RE: Approval of Alternative Corrective Measure
for Soil Remediation
World Kitchen, Inc.
OHD 045 205 424

We have completed a review of the *Evaluation of Supplemental Alternative Corrective Measure Remediation* letter report initially submitted on May 4, 2006. A revised evaluation was submitted on June 12, 2006, to address preliminary comments provided by EPA in a May 15, 2006, e-mail. The evaluation of alternative corrective measures was discussed at a February 14, 2006, teleconference call and requested by EPA in a February 15, 2006, e-mail.

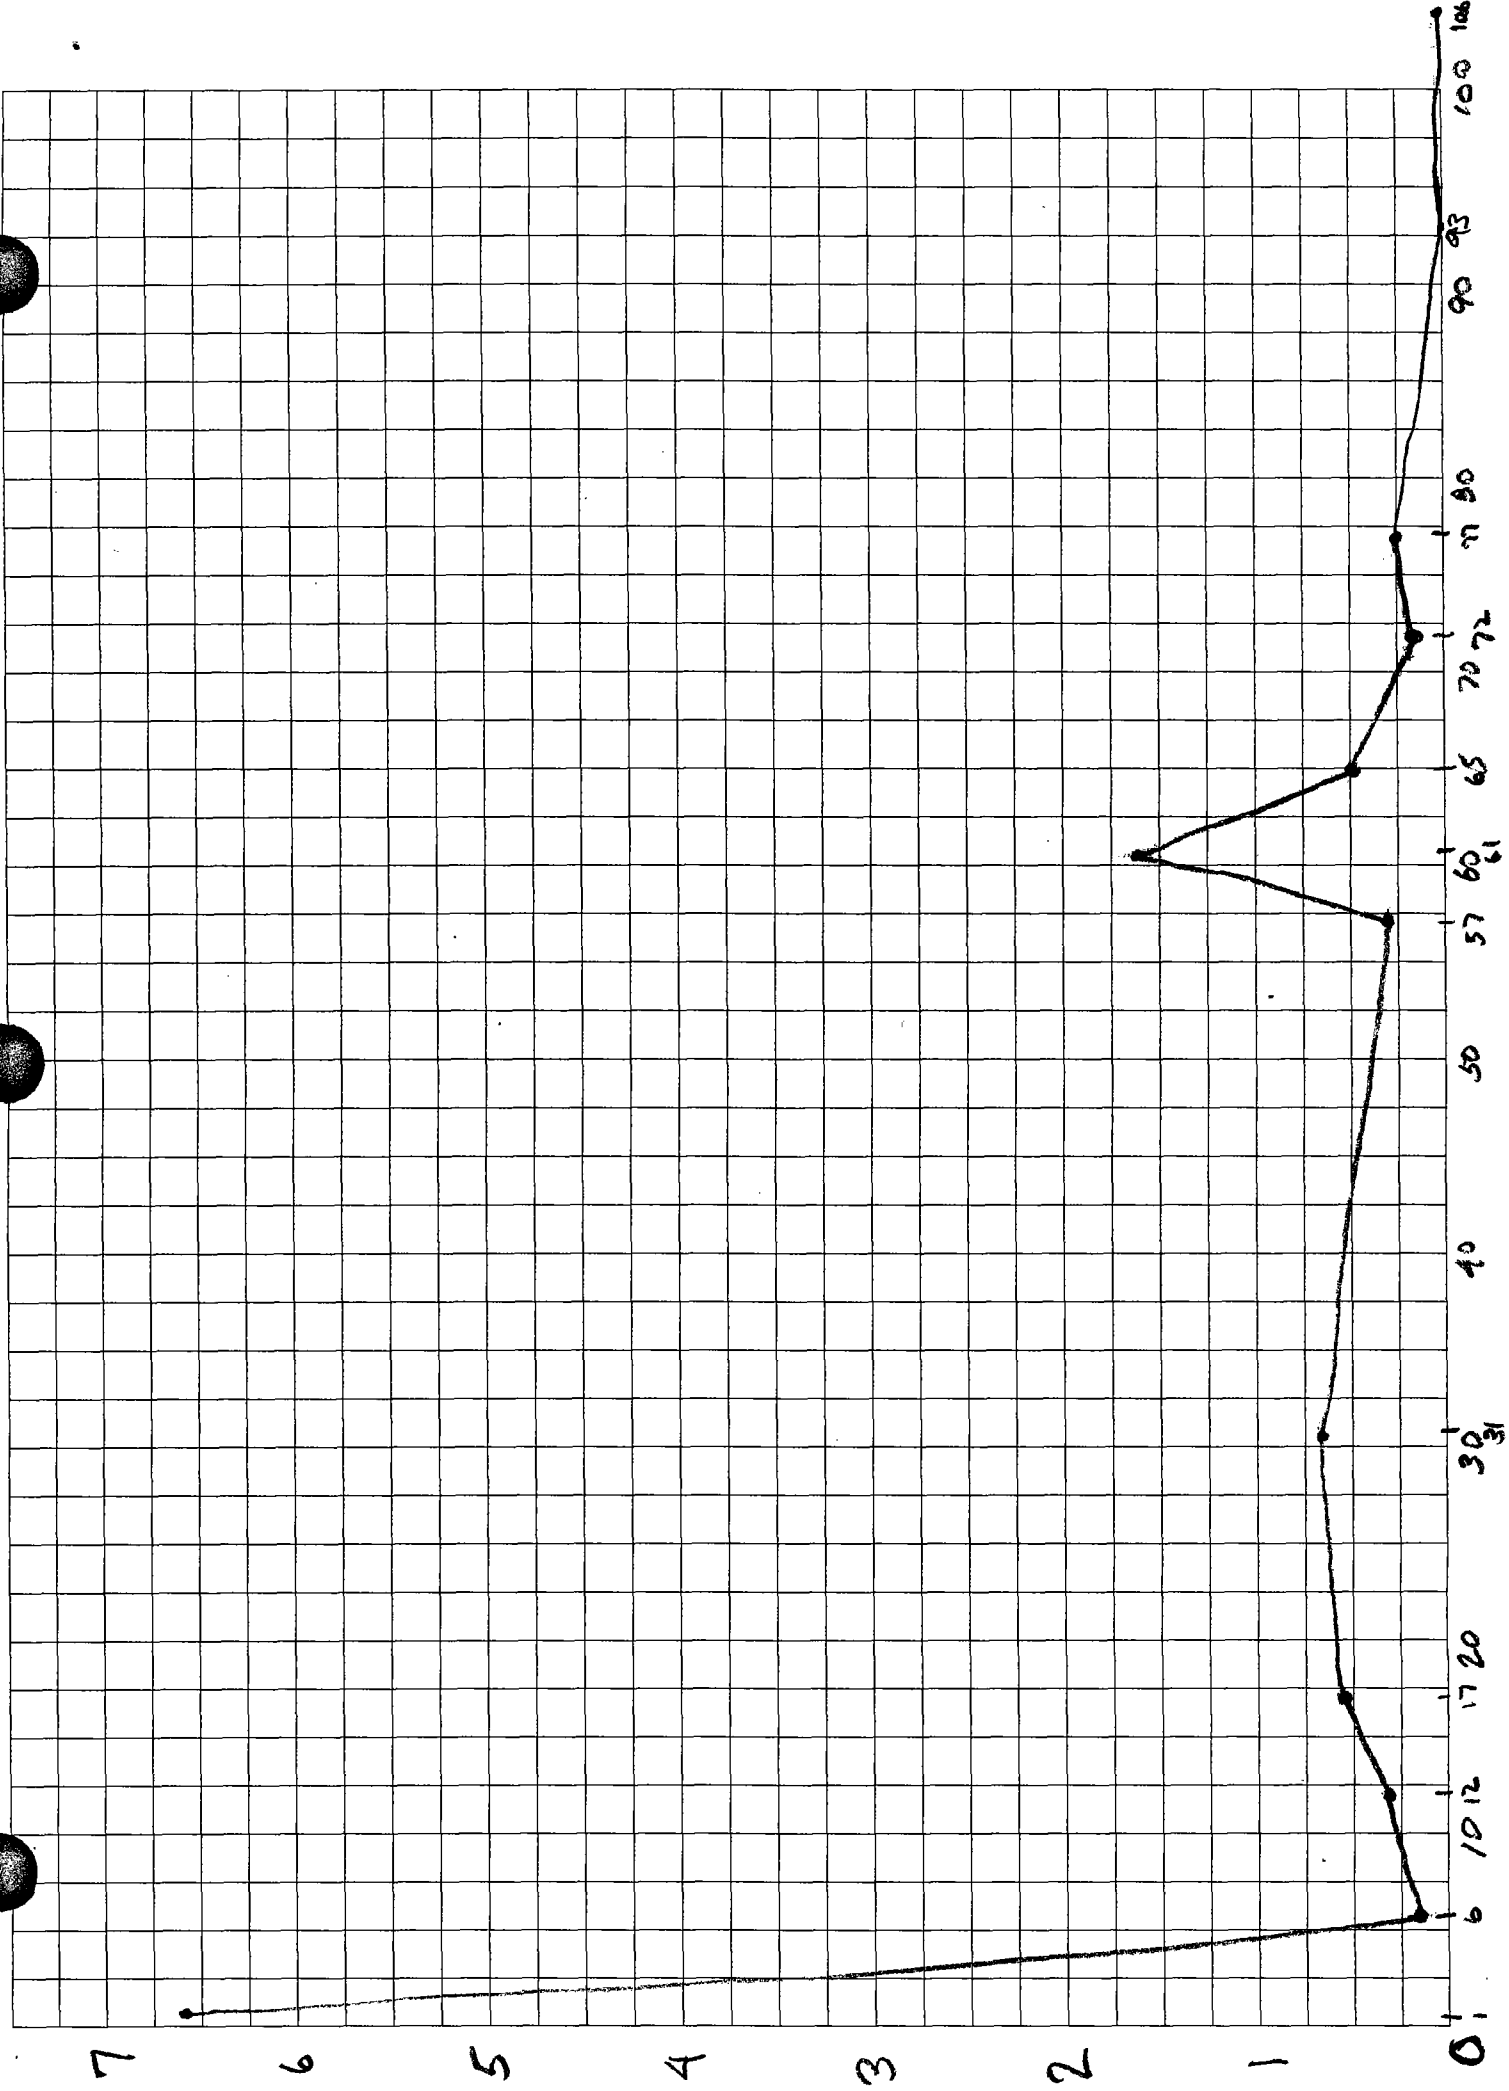
In Area #2, add 2 borings, 1 between SB-15-00 and SB-16-00, and 1 between SB-17-00 and V203.

In Area #4, add 3 borings, 1 between SB-11-00 and SB-13-00, 1 between SB-11-00 and SB-12-00, and 1 between SB-14-00 and SB-09-00.

Figure 1 VOC Concentrations
Well OWS 1

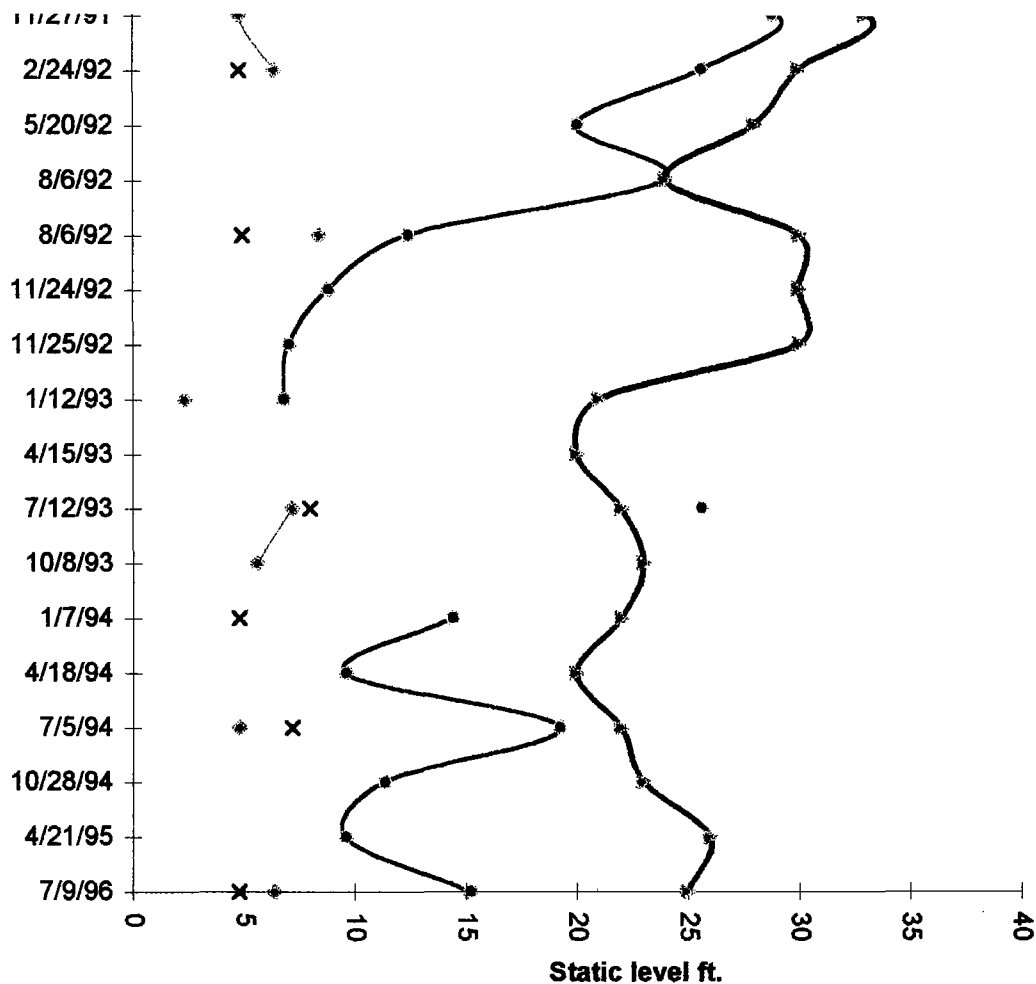
COWC agrees that contamination is flowing from the Ekco site and contamination at R-12 is attributed to the Ekco spill. COWC can not positively identify the location of the leading edge of the contamination plume. COWC has analyzed wells OWS 1, 2, and 3 on a routine basis since October, 1987 and has detected the following: vinyl chloride (VC), 1,1, dichloroethane (1,1 DCA) and cis 1,2 dichloroethylene (cis 1,2 DCE) (Figure 1).
